HISTORIC AND DESIGN REVIEW COMMISSION

July 06, 2016

Agenda Item No: 5

HDRC CASE NO: 2016-226
ADDRESS: 124 ADAMS ST
LEGAL DESCRIPTION: NCB 932 BLK 1 W 150 FT OF 12
ZONING: RM4 H HE
CITY COUNCIL DIST.: 1
DISTRICT: King William Historic District
LANDMARK: Wagner House #3
APPLICANT: Billy Lambert/French & Michigan
OWNER: Charles & Carolyn Adams
TYPE OF WORK: Landscaping, accessory structure modifications and construction of a carport
REQUEST:

NEW FENCING

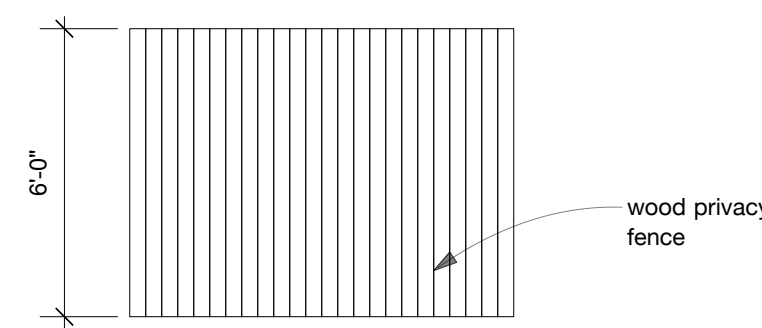
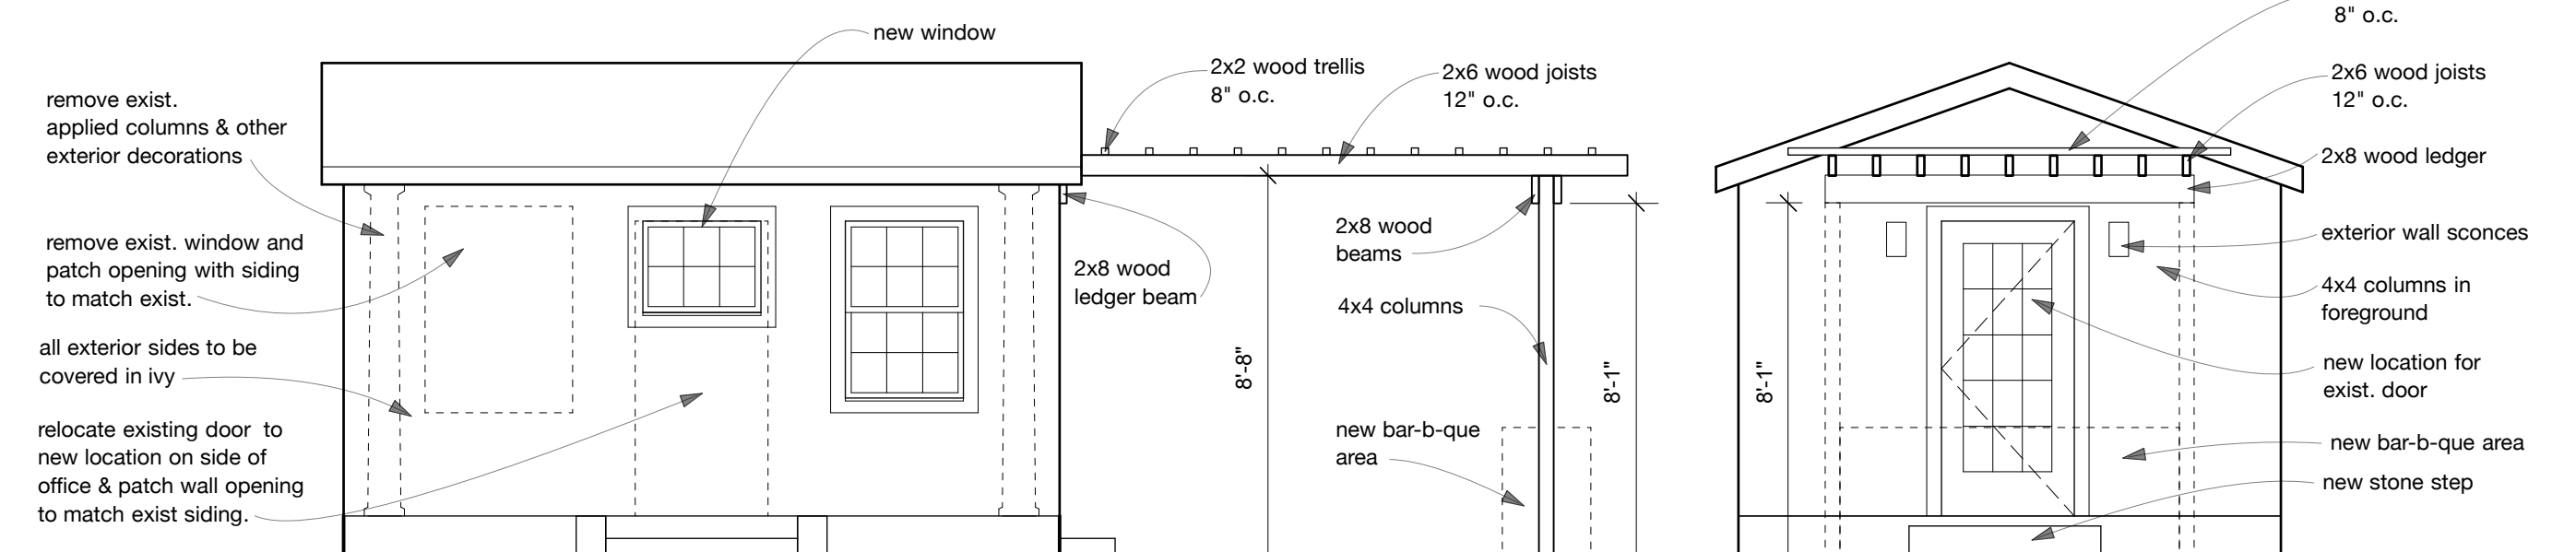
- j. TREES – The applicant has proposed to relocate two existing fig trees and a palm tree within the rear yard. Staff finds this proposal appropriate.
- k. FENCING – The applicant has proposed to replace the existing rear wood privacy fence with a new wood fence to be six (6) feet in height. Additionally the applicant has proposed to replace the existing front wood picket fence with a new wood picket fence to be three (3) feet in height. Both of the proposed installations are appropriate and consistent with the Guidelines for Site Elements 2 in regards to fencing.

Staff recommends approval of items #1 through #5 with the stipulation that the applicant provide additional information on the driveway gate's metal component.

SITE DEVELOPMENT

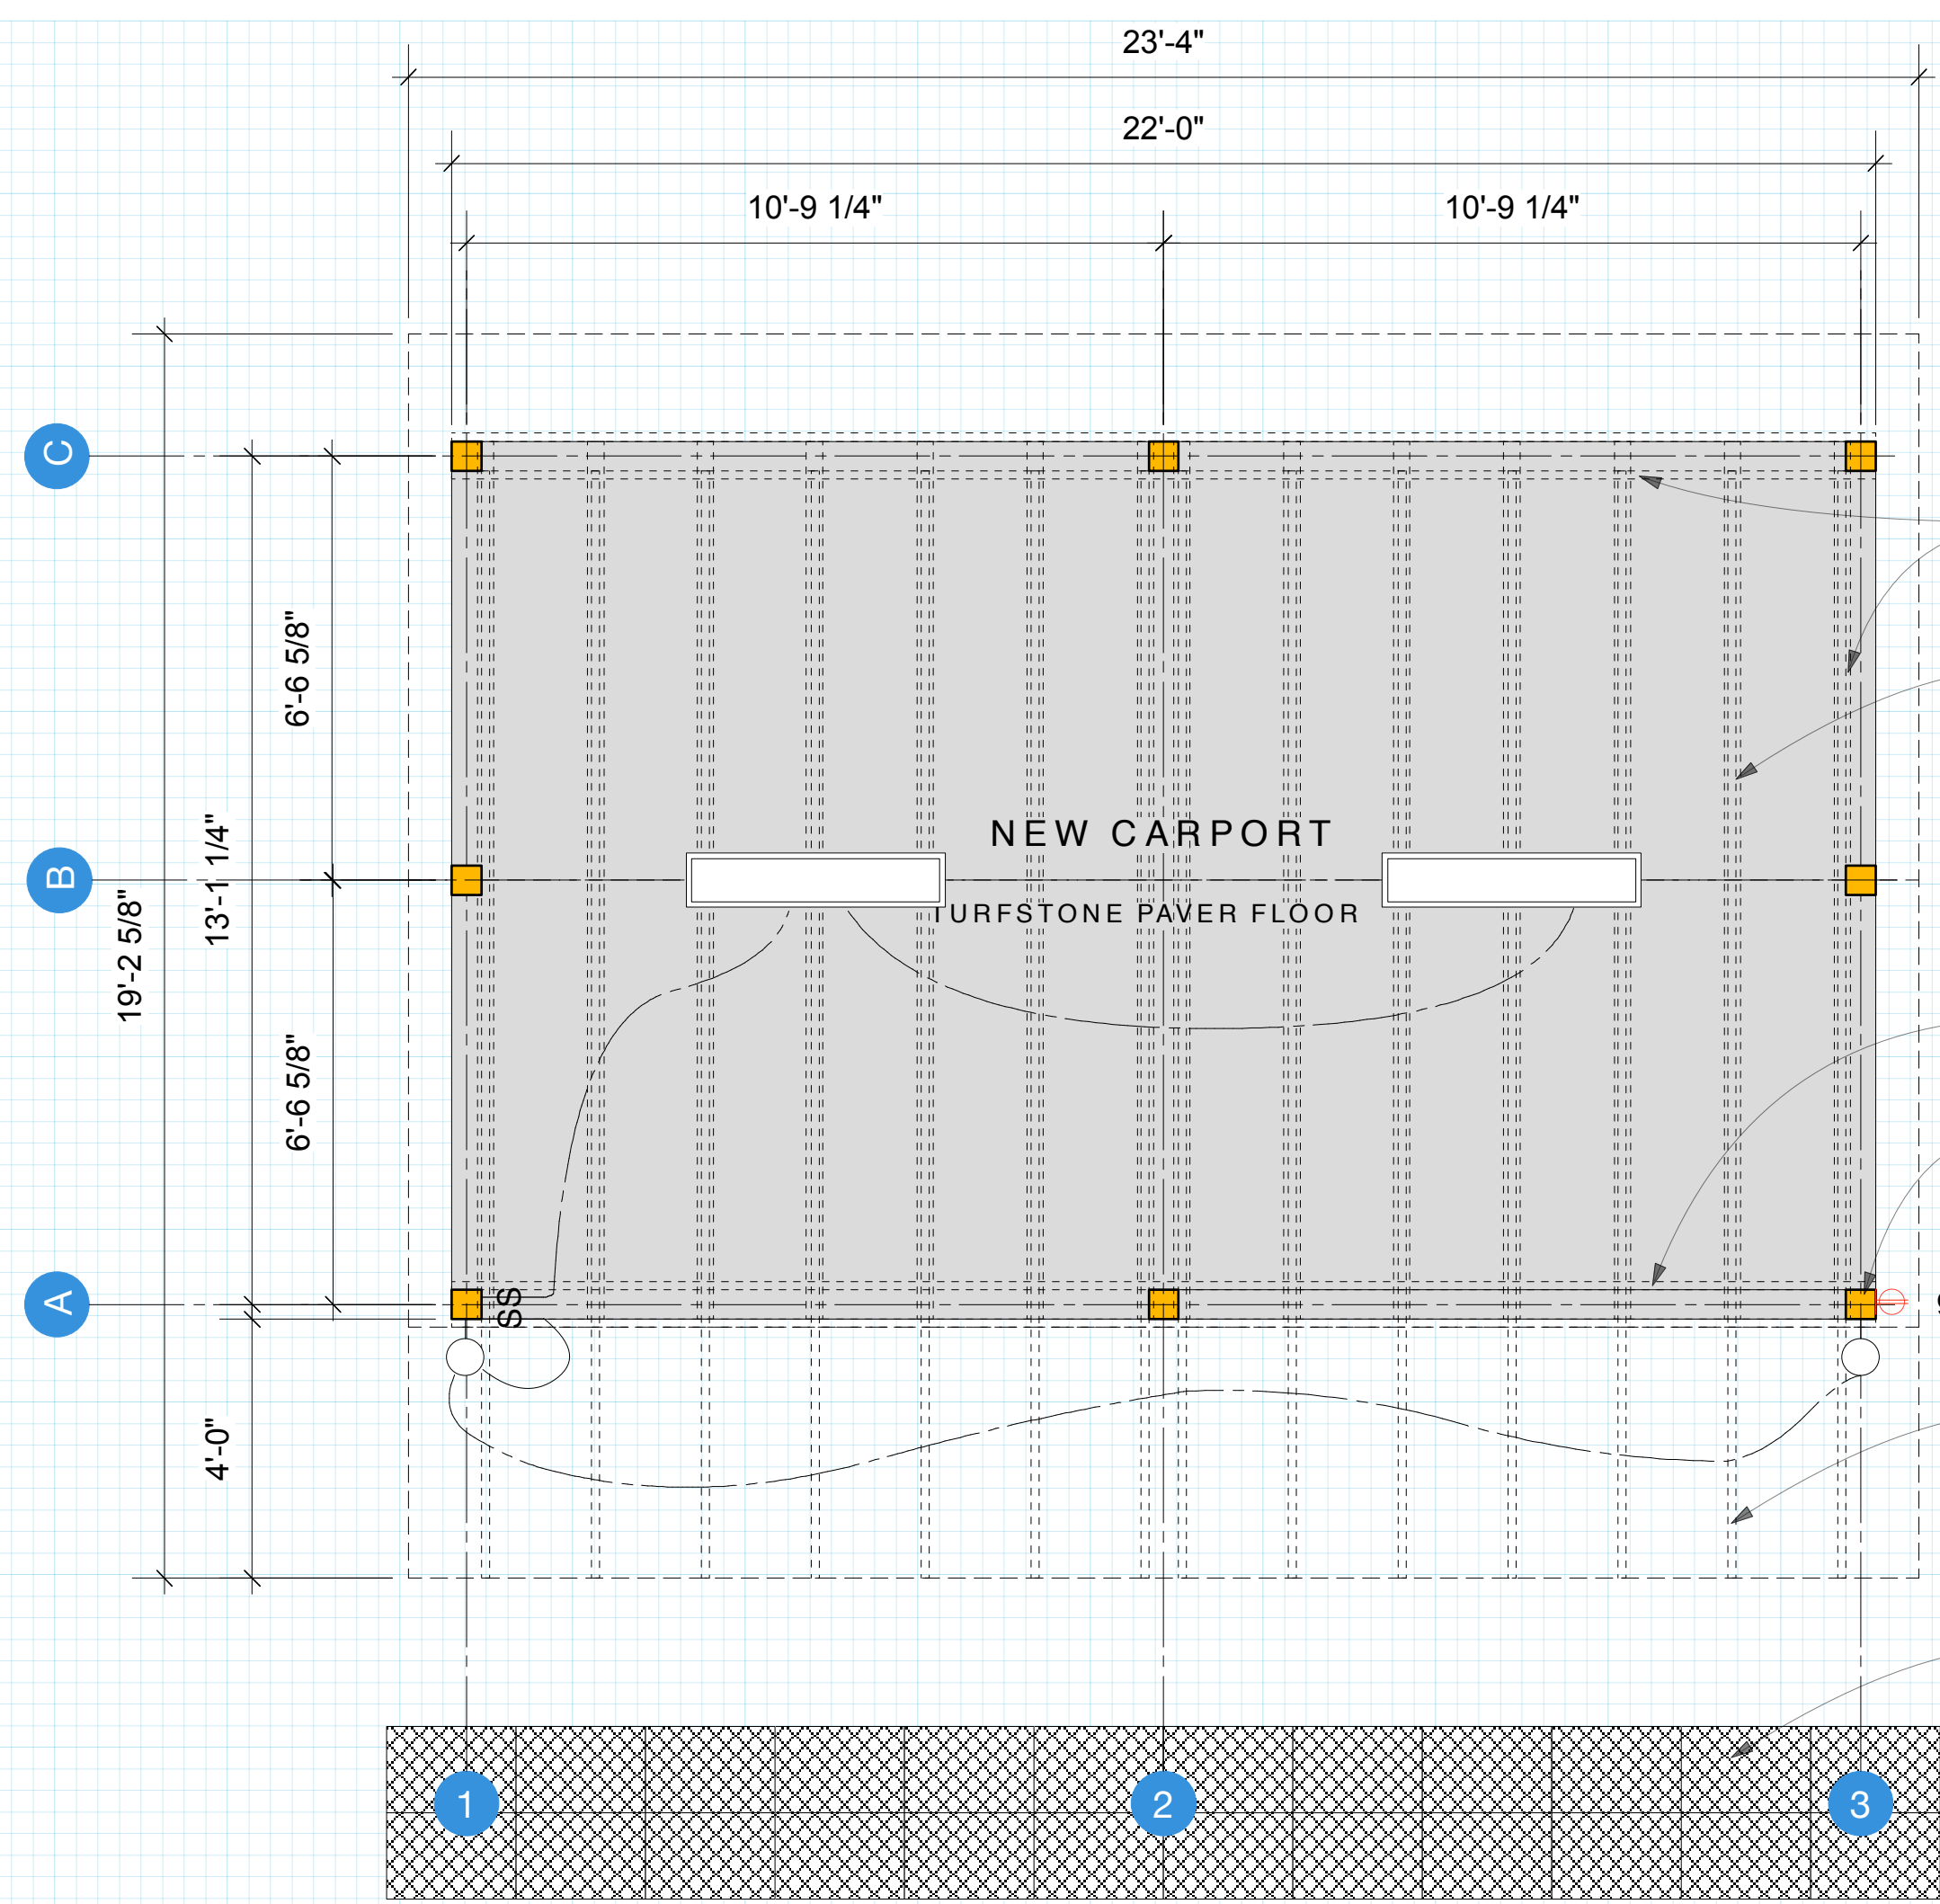
- g. CARPORT – At the rear of the primary historic structure, the applicant has proposed to construct a carport to feature a footprint of approximately 285 square feet and feature an overall height of approximately fifteen (15) feet. According to the Guidelines for New Construction, new accessory structures should be subordinate in massing and form to the primary historic structure. The applicant’s proposal is consistent with the Guidelines.

- h. CARPORT – The applicant has proposed to clad the sides of the rear of the proposed with Hardi Board siding in addition to the proposed wood frame construction. The applicant has noted that the proposed carport will feature a corrugated metal roof to match the existing screened porch’s roof at the rear of the primary historic structure. The applicant’s proposed materials are consistent with the Guidelines for New Construction 5.A.iii.
